DEVELOPMENT APPLICATION ASSESSMENT REPORT

Application Number:	DA2024/1194
----------------------------	-------------

Responsible Officer:	Stephanie Gelder
Land to be developed (Address):	Lot 13 DP 14017, 618 Barrenjoey Road AVALON BEACH NSW 2107
Proposed Development:	Demolition works and construction of a dwelling house including a carport
Zoning:	R2 Low Density Residential
Development Permissible:	Yes
Existing Use Rights:	No
Consent Authority:	Northern Beaches Council
Land and Environment Court Action:	No
Applicant:	Cristina Gomes

Figure 1. North-East Elevation (red highlighting building envelope variation)

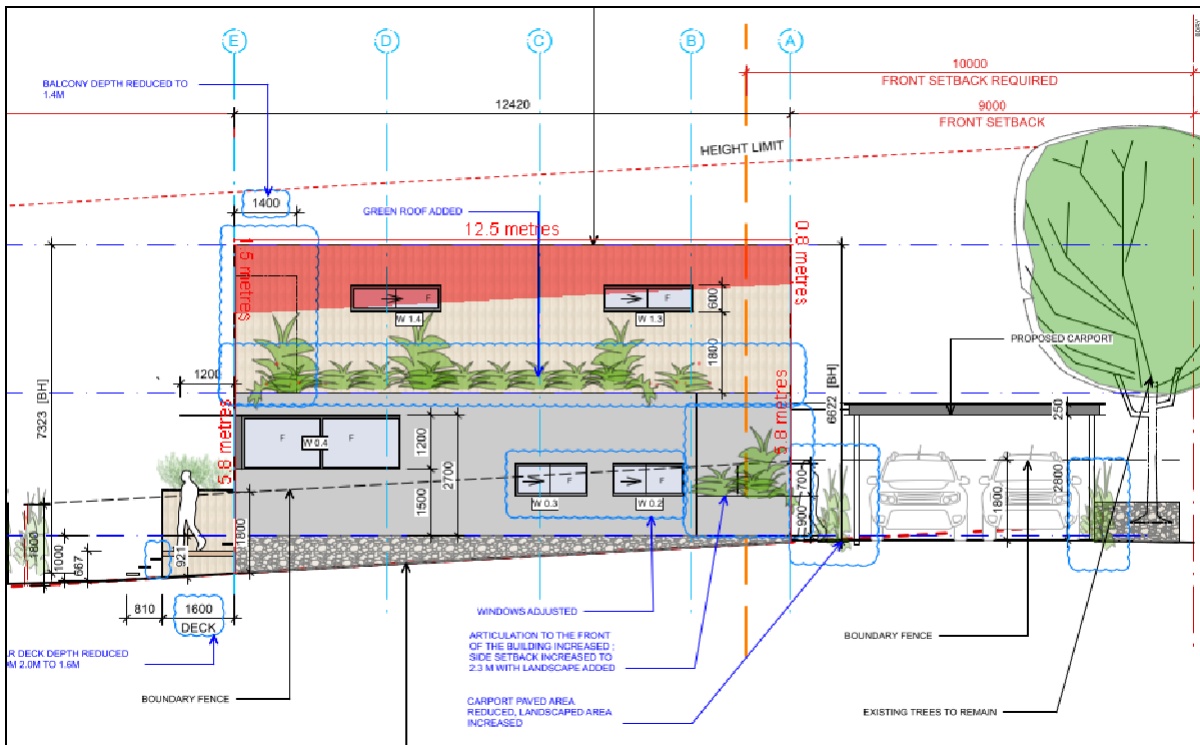
The proposal presents encroachments within the building envelope along the North-East and South-West Elevations. The proposal along the North-East Elevation presents a maximum variation of 1.5 metres in height for a horizontal length of 12.5 metres (see Figure 1). The proposal along the South-West Elevation presents a maximum variation of 2.4 metres in height for a horizontal length of 12.5 metres (see Figure 2).

It is considered that the variations to the building envelope control are unacceptable, and present significant breaches along both the North-East Elevation and South-West Elevation. The breach along the North-East Elevation are attributed to the variation to the side building line, and whilst the side
